Service Bulletin

Bulletin No. ZSM00232

Model: IC-F5060 series

Subject: Enabling modulation input through the ACC connector.

Figure 1: Modification to input modulation through the ACC connector

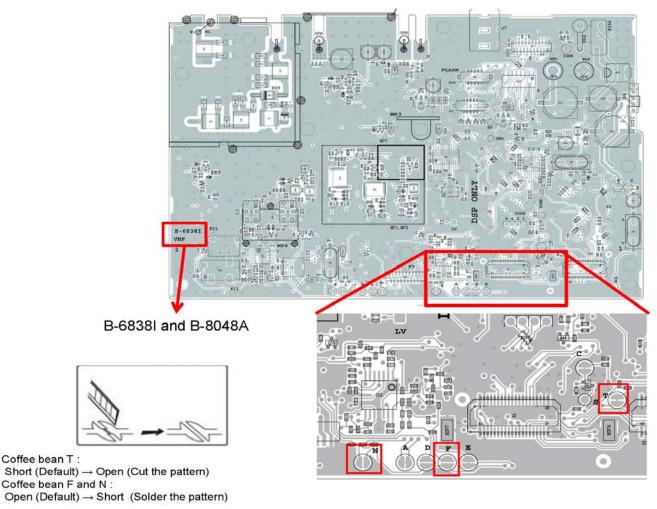
When the IC-F5060 was first released, you could input modulation through pin 8 (EXMOD) of the ACC connector by shorting coffee bean N or F. However, the steps needed to enable EXMOD were changed from a later production lot (see the serial number range information) because coffee bean T was added to the circuit to prevent a malfunction.

If a customer wants to use EXMOD, you must short coffee bean N or F, and also open coffee bean T by cutting its pattern.

Make the modification as shown in the illustrations below.
